| Project | IEEE 802.16 Broadband Wireless Access Working Group < http://ieee802.org/16 > | |
| Title | Changes on CDMA-based BW Request Procedures in OFDMA-PHY for Mobile Environment | |
| Re: | This is a response to a Call for Comments IEEE 802.16e-03/23 on IEEE 802.16e-03/07r4 | |
| Abstract | This document contains suggestions to the improvement of the CDMA-based bandwidth request procedures in OFDMA-PHY. | |

Figure 1. Current CDMA-based bandwidth-request procedure in OFDMA-PHY.

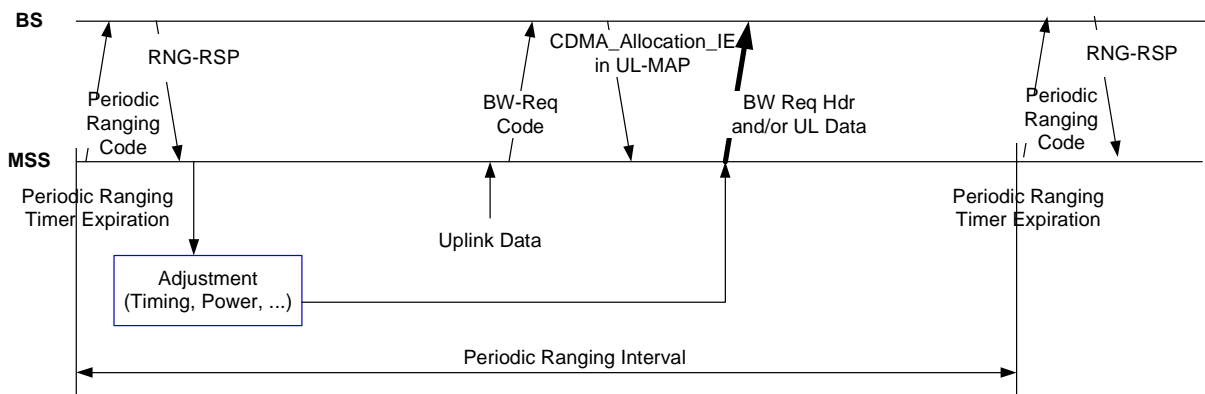
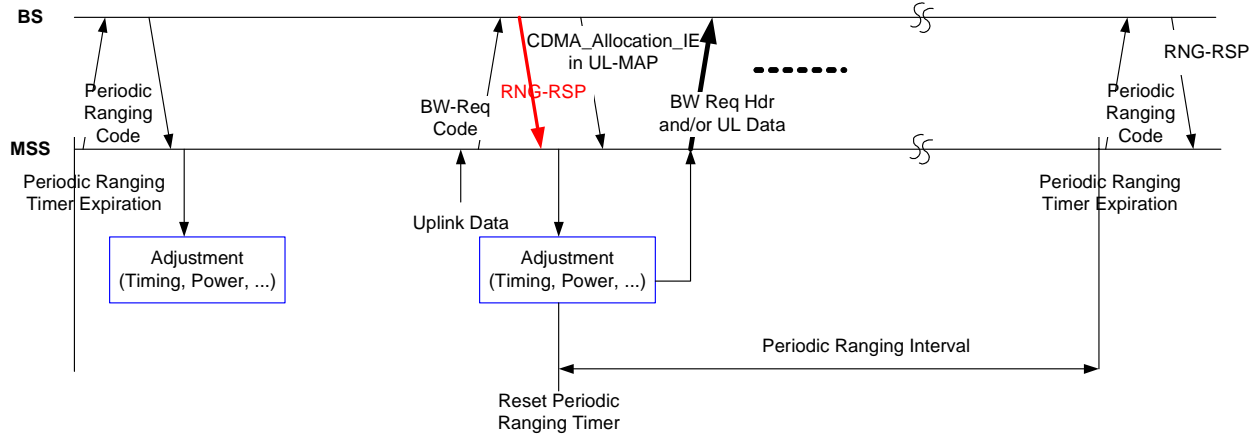
Therefore, we propose the unsolicited RNG-RSP transmission as a response to a CDMA-based bandwidth request before the CDMA_Allocation_IE in UL-MAP for uplink transmission to the MSS as an explicit procedure for a CDMA-based bandwidth request. Then the MSS can adapt to a more recent channel conditions (such as timing and power offset) and send uplink data using appropriate modulation and channel coding.

In Figure 1, we describe the current procedure for CDMA-based bandwidth-request in OFDMA-PHY. And, in Figure 2, we describe the proposed procedure for CDMA-based bandwidth request in OFDMA-PHY.

- The BS may send the unsolicited RNG-RSP as a response to a CDMA-based bandwidth-request.
- When the MSS receives a unsolicited RNG-RSP message after transmitting the bandwidth-request code, it shall reset the periodic ranging timeout, adjust the parameters (timing and power, etc.) as notified in the RNG-RSP message.
